Re: Florida Power & Light Company
Proposed Turkey Point Units 6 and 7
Docket Nos. 52-040 and 52-041
Response to NRC Request for Additional Information Letter No. 58 (eRAI 6434) - Concerning Implementation of Fukushima Near-Term Task Force Recommendations

NRC RAI Letter No. PTN-RAI-LTR-058 Dated May 1, 2012

NRC RAI Number: 01.05-1 (eRAI 6434)

Figure 1: Seismotectonic Source Zones

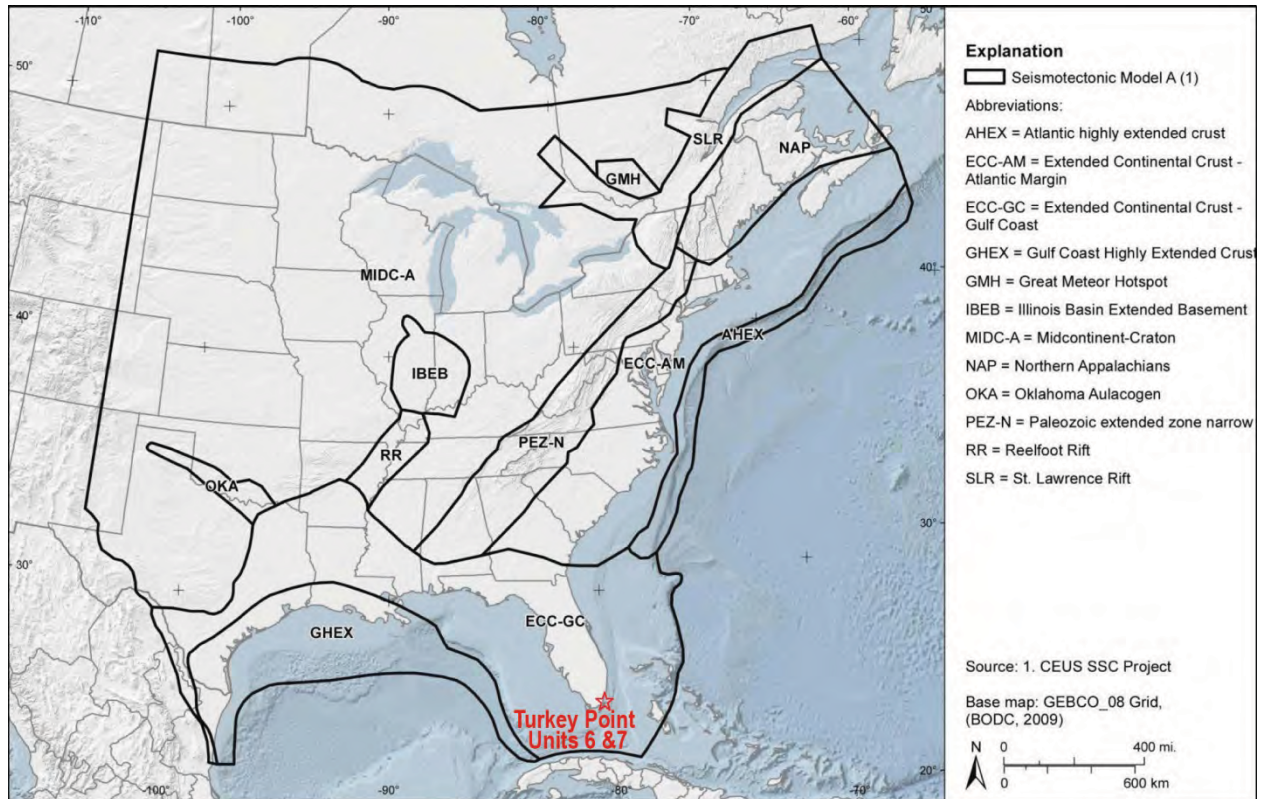
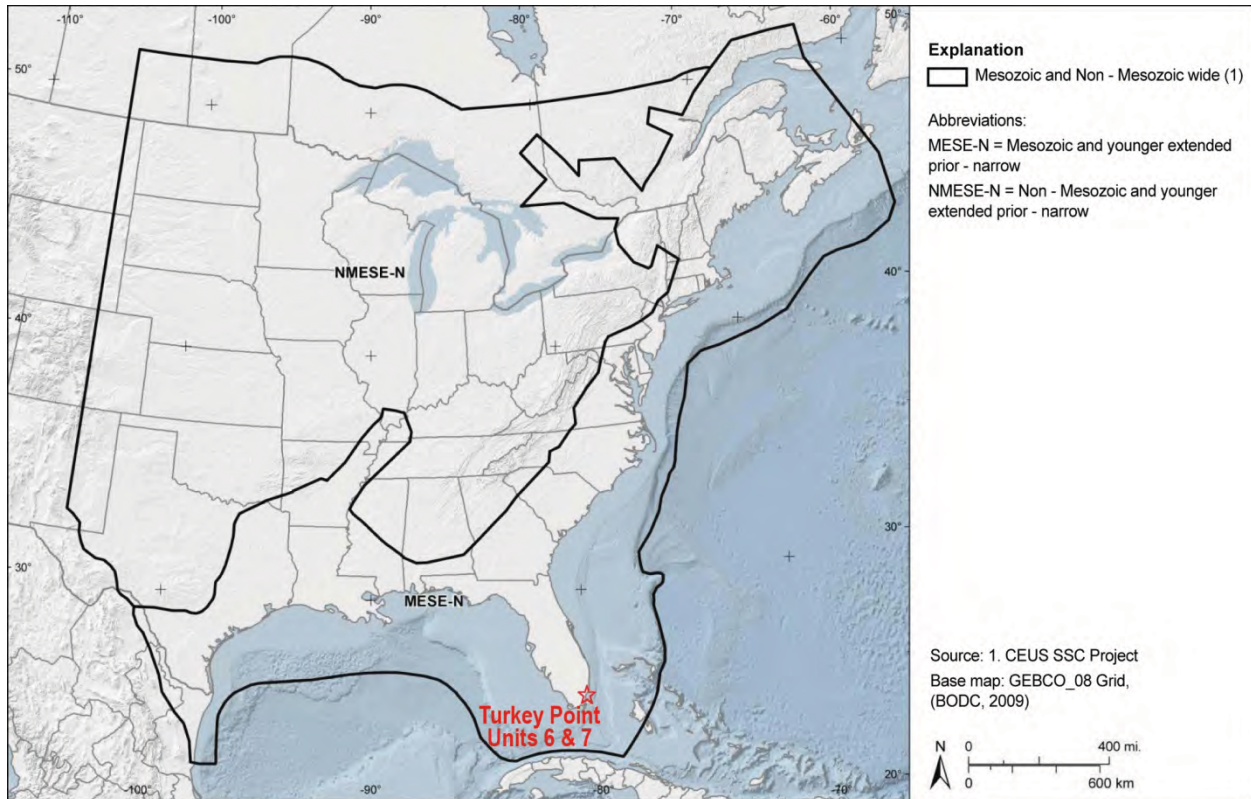
This request for additional information (RAI) specifically addresses Recommendation 2.1, of the Fukushima Near-Term Task Force recommendations contained in SECY-12-0025 as it pertains to the seismic hazard evaluation. This recommendation specifies the use of NUREG-2115, "Central and Eastern United States Seismic Source Characterization for Nuclear Facilities," (CEUS SSC) in a site probabilistic seismic hazard analysis (PSHA). Consistent with Recommendation 2.1, as well as the need to consider the latest available information in the PSHA for Turkey Point Units 6 and 7 planned reactor site, the NRC staff requests that Florida Power and Light:

- a) Evaluate the potential impacts of the newly released CEUS SSC model, with potential local and regional refinements as identified in the CEUS SSC model, on the seismic hazard curves and the site-specific ground motion response spectra (GMRS)/foundation input response spectra (FIRS). For re-calculation of the PSHA, please follow either the cumulative absolute velocity (CAV) filter or minimum magnitude specifications outlined in Attachment 1 to Seismic Enclosure 1 of the March 12, 2012 letter "Request for information pursuant to Title 10 of the *Code of Federal Regulations* 50.54(f) regarding Recommendations 2.1, 2.3, and 9.3, of the near-term task force review of insights from the Fukushima Dai-Ichi accident." (ML12053A340).
- b) Modify the site-specific GMRS and FIRS if you determine changes are necessary given the evaluation performed in part a) above.

Figures 1 and 2 show examples of the source zones of the CEUS Seismic Source Characterization (SSC) model developed in NUREG-2115 (Reference 1). Figure 1 shows example seismotectonic source zones and Figure 2 shows example Mmax source zones. The areal extent of the CEUS SSC model covers the region encompassed by the updated EPRI-SOG seismic sources shown on FSAR Figures 2.5.2-204 through 2.5.2-209. Thus, the CEUS SSC model can be considered as a replacement for the EPRI-SOG (FSAR Reference 2.5.2-245) seismic sources in their entirety. As a consequence, an assessment of the effect of the CEUS SSC model on the total hazard curves for the site can be evaluated by subtracting from the existing total hazard the contribution of the updated EPRI-SOG sources and then adding the hazard contributed by the CEUS SSC model sources to produce total hazard values for the purpose of the sensitivity analysis.
